10/552,032

Office Action Summary

LINDEMANN, ANDREAS

DETAILED ACTION

FIG. 7

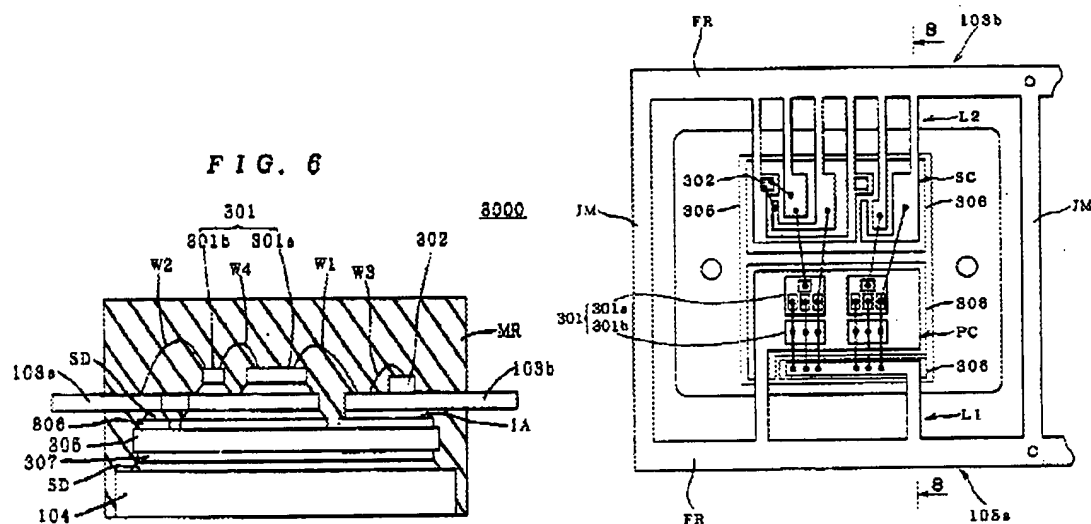
En re Claim 1, Noda et al '573 discloses a substrate (Fig 7, item 305) of a ceramic insulation material (Col 12, lines 25-33) with islands (Fig 7, item 306) comprising a thermally and electrically conductive material (Col 12, lines 34-36, examiner's note: it is well known in the art that copper is a thermally and electrically conductive material), at least two power semiconductor chips (Fig 7, items 301a and 301b) arranged on the islands (Fig 7, item 306), electrical connections (Fig 6, Items W1, W2, W3, and W4) from the chips (Fig 7, items 301a and 301b) to connecting elements (Fig 7, items 103a and 103b), wherein at least two connecting elements (Fig 7, items 103a and 103b) are electrically connected (Fig 6, Items W1, W2, W3, and W4) to the islands (Fig 7, item 306), wherein an enclosure (Fig 6, item MR) of pressed plastic material (Col 13, line 2) is provided which fully surrounds the power semiconductor chips (Fig 6, items 301a and 301b) and at least partially surrounds the substrate (Fig 6, item 305), wherein the connecting elements (Fig 6, items 103a and 103b) are designed as flat conductor connections projecting from the enclosure (Fig 6), and the substrate

(Fig 6, item 305) exhibits a metal coating (Fig 6, item 307) on a side opposite (Fig 6) the islands (Fig 6, item 306).

En re Claim 2, Noda et al '573 discloses wherein the islands (Fig 7, item 306) include separate partial surfaces (Col 13, lines 7-8) of a metal layer (Col 12, lines 34-36).

En re Claim 7, Noda et al '573 discloses wherein the electrical connections (Fig 7, items W1, W2, W3, and W4) comprise wire connections (Col 12, lines 54-61) and/or connections via the islands.

En re Claim 8, Noda et al '573 discloses wherein the connecting elements (Fig 7, items 103a and 103b) are located on two different sides of the enclosure (Fig 7).

En re Claim 9, Noda et al '573 discloses wherein the connecting elements (Fig 7, item 103a) are arranged and connected to the chips (Fig 7, item 301) so that connecting

elements conducting (Fig 7, item L1) a main current are arranged adjacent to each other (Fig 7, item 301).

En re Claim 10, Noda et al '573 discloses wherein the connecting elements (Fig 7, items 103a and 103b) are arranged and connected to the chips (Fig 7, item 301) so that two connecting elements (Fig 7, item L2), which are provided with potentials which have a high mutual potential difference, are arranged further from each other than two connecting elements with potentials which have a low mutual potential difference (Fig 7, items L1).

En re Claim 13, Noda et al '573 discloses wherein the chips comprise MOSFET, diode (Fig 7, item 301b), IGBT (Fig 7, item 301a) and/or thyristor chips.

FIG. 8

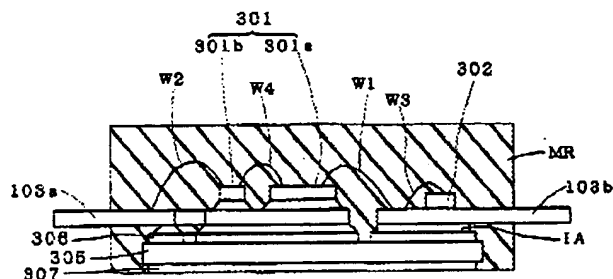
En re Claim 4, Noda et al '573 discloses wherein the metal coating (Fig 8, item 307) of the substrate (Fig 8, item 305) is at least partially exposed (Col 13, line 57-62) on the side opposite the islands (Fig 8, item 306).

FIG. 1

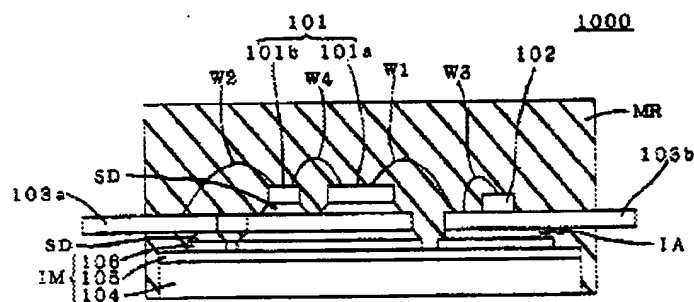
En re Claim 6, Noda et al '573 discloses wherein the electrical connections comprise soldered connections (Fig 1, item SD).

En re Claim 11, Noda et al '573 discloses wherein the chips (Fig 1, item 101) are secured to a metal island (Fig 1, item 106) by means of soldered connections (Fig 1, item SD).
